Office Action Summary	Application No. 10/590,066	Applicant(s) MASON ET AL.	
	Examiner PHILLIP NGUYEN	Art Unit 2828

DETAILED ACTION

3. Claims 1-2, 4-5, 9, 23 are rejected under 35 U.S.C. 102(b) as being anticipated by

FIG. 1

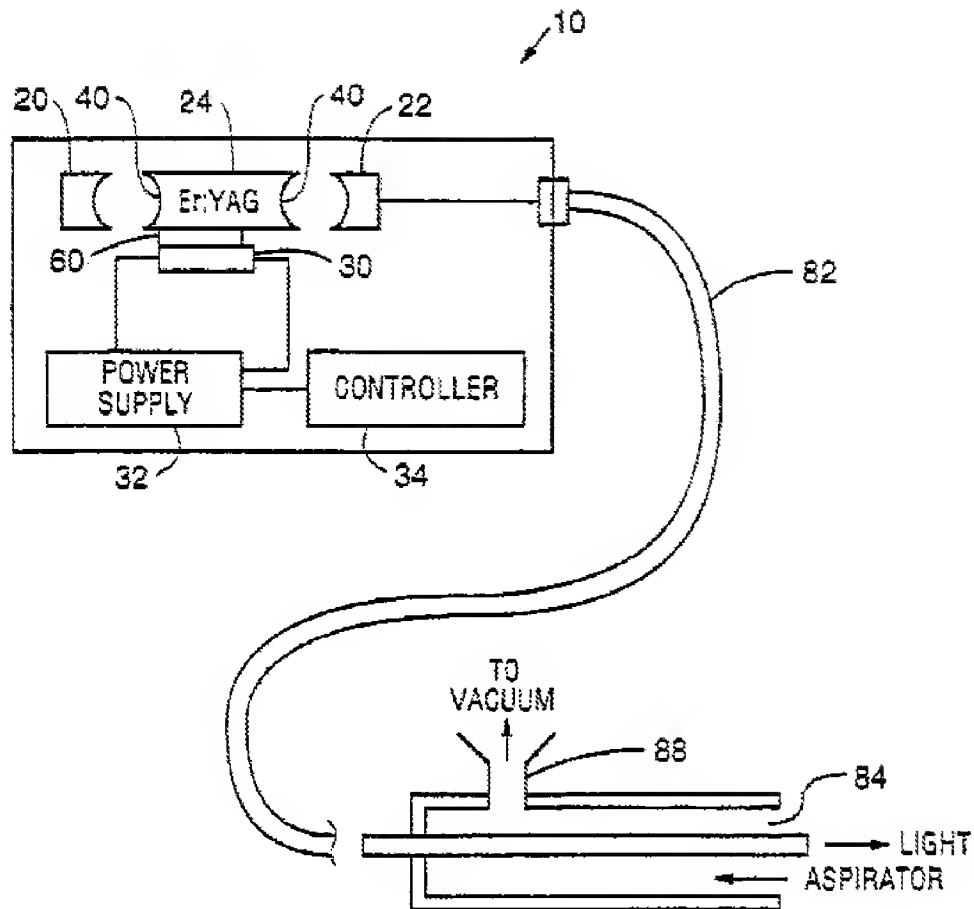
With respect to claim 1, Mitchell discloses in Fig. 1 a solid state laser gain medium 24 having first and second ends 40 along a laser optical axis in which at least one end is profiled to provide a level of thermal lensing at a predetermined operating power, in which the

predetermined beam quality is centered substantially on a maximum at the predetermined operating pump power (col. 4, lines 49-58).

With respect to claim 2, Fig. 1 illustrates both ends of the solid-state laser gain medium are profiled.

With respect to claim 4, Fig. 1 further illustrates a laser cavity (defined by mirrors 20 and 22) including a solid state laser gain medium as defined in claim 1.

With respect to claim 5, Mitchell discloses the cavity end reflectors 20 and 22 as concave mirrors but further teaches the mirrors could be flat as well (col. 5, lines 60-62).

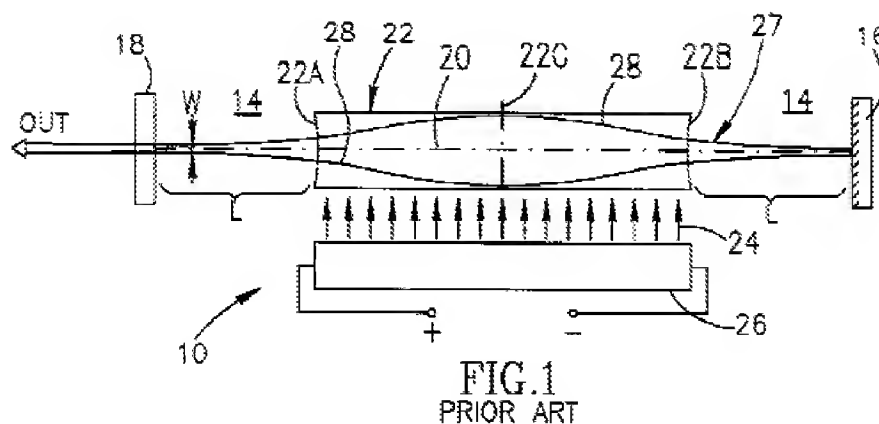
With respect to claims 1, 36, 38, Angeley discloses in Fig. 1 a solid state laser gain medium 22 having first and second ends 22A and 22B along a laser optical axis 20 in which at least one end is profiled to provide a level of thermal lensing at a predetermined operating power, in which the predetermined beam quality is centered substantially on a maximum at the predetermined operating pump power (col. 3, lines 47-61).

With respect to claim 2, Fig. 1 clearly illustrates both ends 22A-22B of the solid-state laser gain medium are profiled.

With respect to claim 5, Angeley discloses Fig. 1 (prior art) which shows both cavity end reflectors 16 and 18 are flat.

With respect to claim 10, Angeley discloses that the pump source 24 is flash lamp but those skilled in the art will also recognize without further illustration that pump-light 24 may be provided by one or more diode-laser arrays. According to the Fig. 1, laser medium 22 is pumped on the side.

With respect to claims 27-28, Fig. 1 illustrates one or both first and second ends 22A and 22B to form a lens having a predetermined focal length (depending on the curvature of the profiled portion).
